Section 16 Planning Application for Proposed Minor Relaxation of Plot Ratio Restriction for Permitted Flat Use (Proposed Amendments to an Approved Scheme with Minor Relaxation of Plot Ratio Restriction under Application No. A/H6/91) at 4, 4A, 4B and 4C Tai Hang Road, Hong Kong (Application No. A/H6/97)

Section 16 Planning Application for Proposed Minor Relaxation of Plot Ratio Restriction for Permitted Flat Use (Proposed Amendments to an Approved Scheme with Minor Relaxation of Plot Ratio Restriction under Application No. A/H6/91) at 4, 4A, 4B and 4C Tai Hang Road, Hong Kong (Application No. A/H6/97)

Responses to Departmental Comments

FIGURE NO.: A1		PROJECT TITLE: Residential Redevelopment at Nos 4-4C Tai Hang Road, Hong Kong	 CTA Consultants Limited 志達顧問有限公司
PROJECT NO.: 26021HK		DRAWING TITLE: INDEX PLAN OF PUBLIC TRANSPORT ASSESSMENT	
SCALE: 1 : 2500 @A4	DATE: 23 JUL 2026

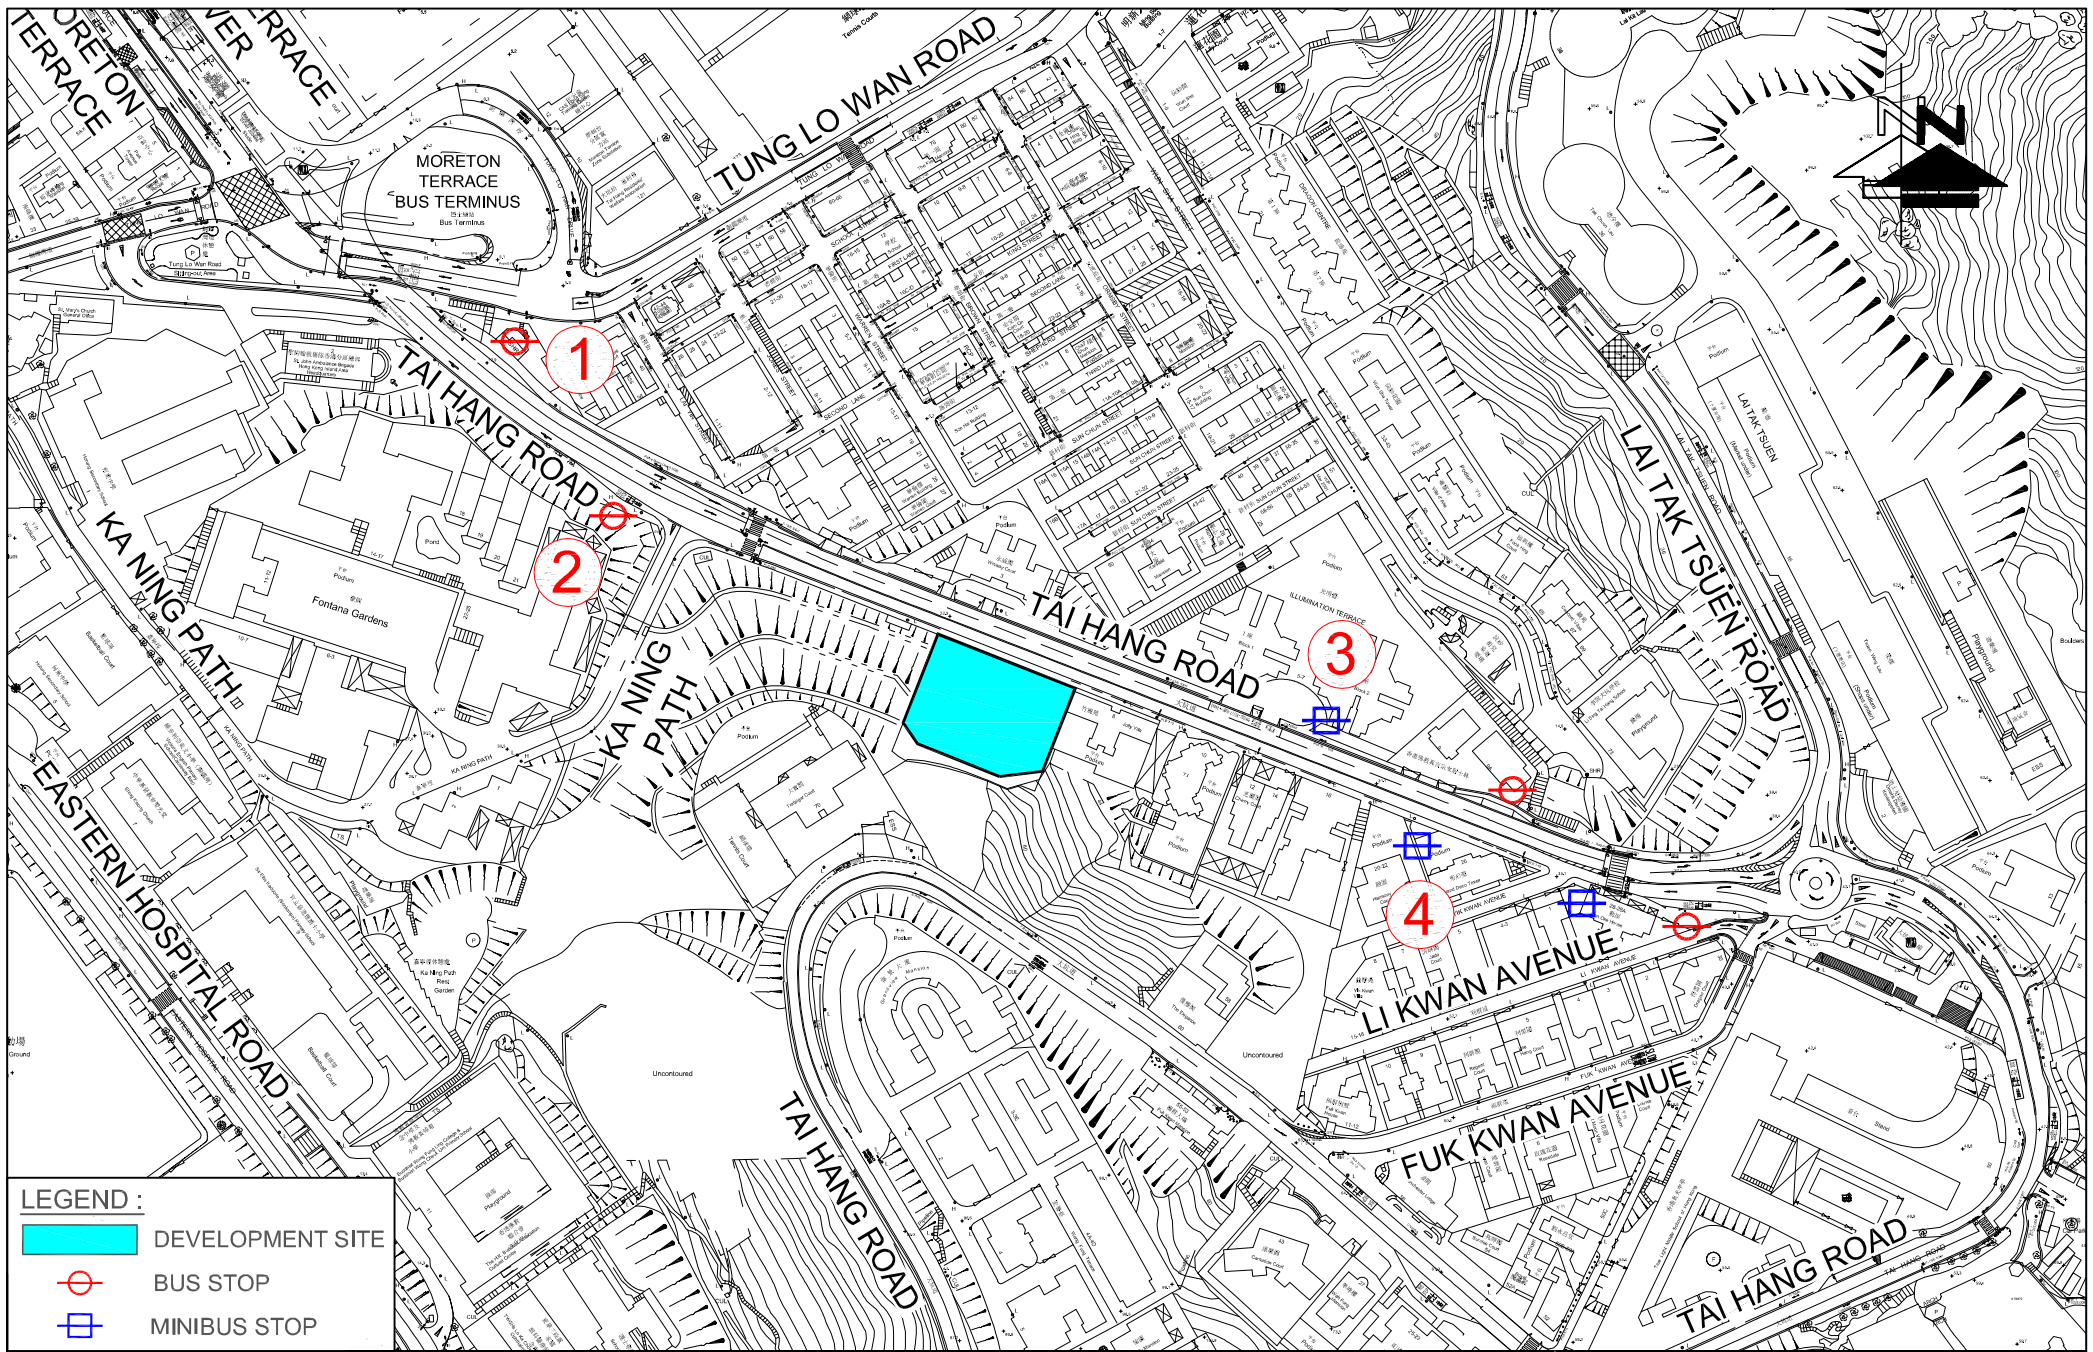
Departmental Comments	Responses to Comments
1.	Comments of Transport Department (Transport Operation)	
1.1	It is noted that the increase in the number of flats placing undue strain on public transport. Please find the following comment on the TIA from public transport operation viewpoint: - Referring to table 3.3 of the TIA, the applicant should provide recent occupancy rate (i.e. arranging on-site survey) of the mentioned PT services to demonstrate the sufficiency of PT would not be affected by the proposed development.	A public transport survey was carried out on 25 March 2026 during the AM peak and PM peak periods on the nearest PT stops at Tai Hang Road. As requested, the findings from the PT survey are summarized in Attachment 1 for reference. It is concluded that the proposed development would generate limited no. of PT demand and the existing PT services in both AM and PM peak would have ample capacities for the future demand by year 2033. There are sufficient PT capacities to cater for future PT demand.

- 1.1 A public transport survey was carried out at the nearest existing PT stops on Tai Hang Road on 25 March 2026 during the AM and PM peak periods. The location is shown in **Figure A1**. The findings are summarized in the **Tables A1** below.

- 1.4 It is concluded that the proposed development would generate limited no. of public transport demand and the existing public transport services in both AM and PM peak would have ample the capacities for the future demand by year 2033.

Comparison of Podium Bulk and Vertical Greening
of the Approved Scheme and the Proposed Scheme

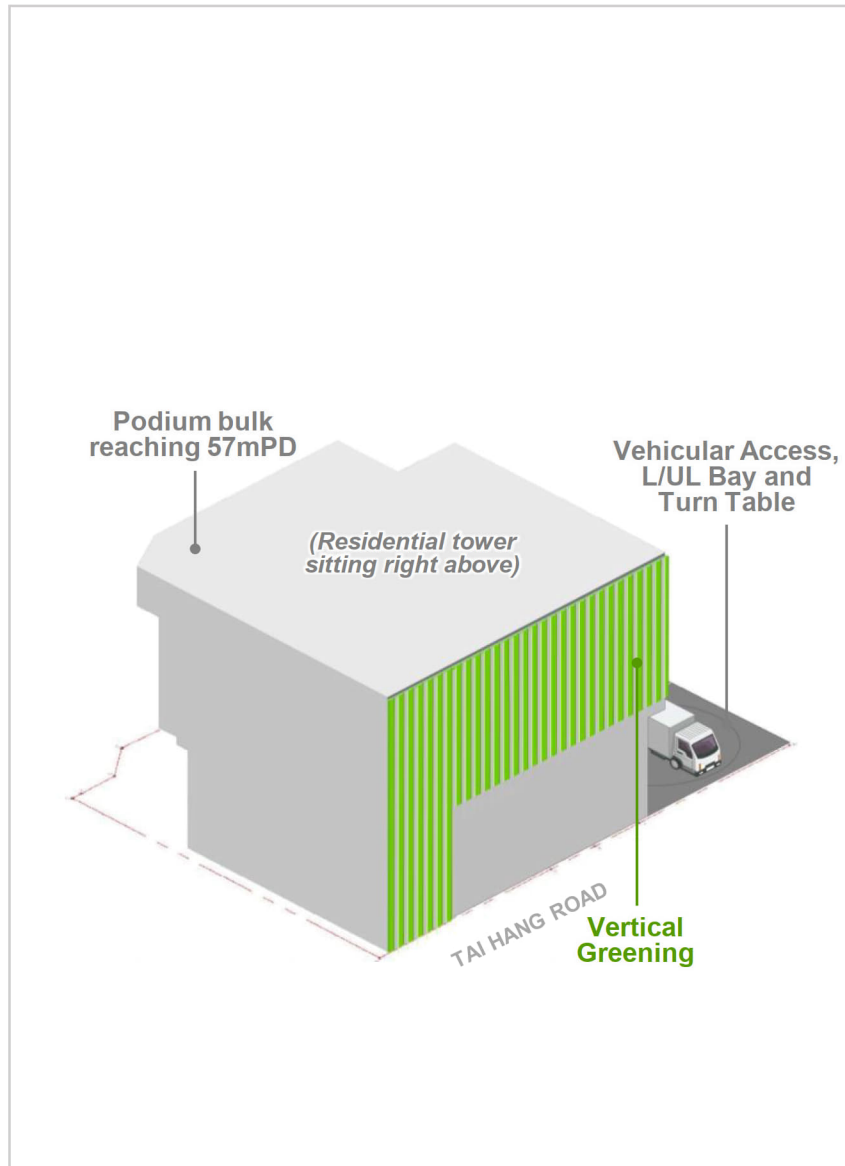
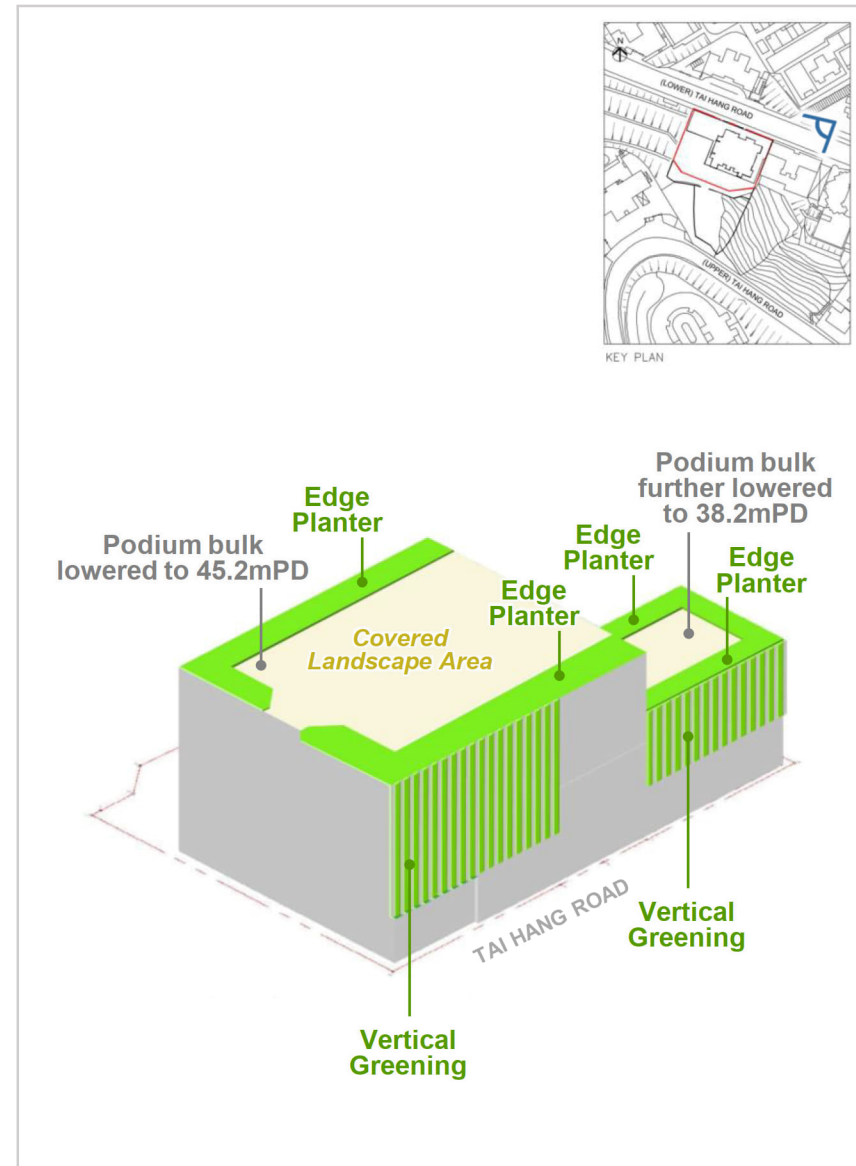
2.	Comments of Planning Department – Hong Kong District Planning Office (Verbal comments received on 23 July 2026)	
2.1	It is suggested to provide more illustration(s) to visualise the podium bulk and vertical greening of the Proposed Scheme as compared with the Approved Scheme.	An illustrative diagram showing a comparison of the podium bulk and vertical greening of the Approved Scheme and the Proposed Scheme is provided in Attachment 2 for reference. As shown in the diagram, under the Proposed Scheme, the Applicant has reduced the podium height from 57mPD to 45.2mPD. After reducing the podium height significantly, the podium length has to be extended along the frontage of Tai Hang Road inevitably to accommodate the necessary parking and E&M facilities. Yet, effort has been made to minimize the height of the extended portion of the podium as far as practicable. Compared with the height of the main portion of the podium at 45.2mPD, the height of the extended portion of the podium is minimized to 38.2mPD only, facilitating air ventilation above.

Departmental Comments	Responses to Comments
		To further mitigate its bulk, quality landscaping is incorporated on the flat roof of the podium, with planters provided along the podium edges in the northern (facing Tai Hang Road), western and southern sides to enhance the landscape and amenity. Vertical greening is also provided along the podium façades in the northern (facing Tai Hang Road) and western sides, which helps shield the retaining slope structure at the back to provide effective visual relief. This offers a more comfortable environment for pedestrians compared to the vehicular access, L/UL bay and turn table in the Approved Scheme.
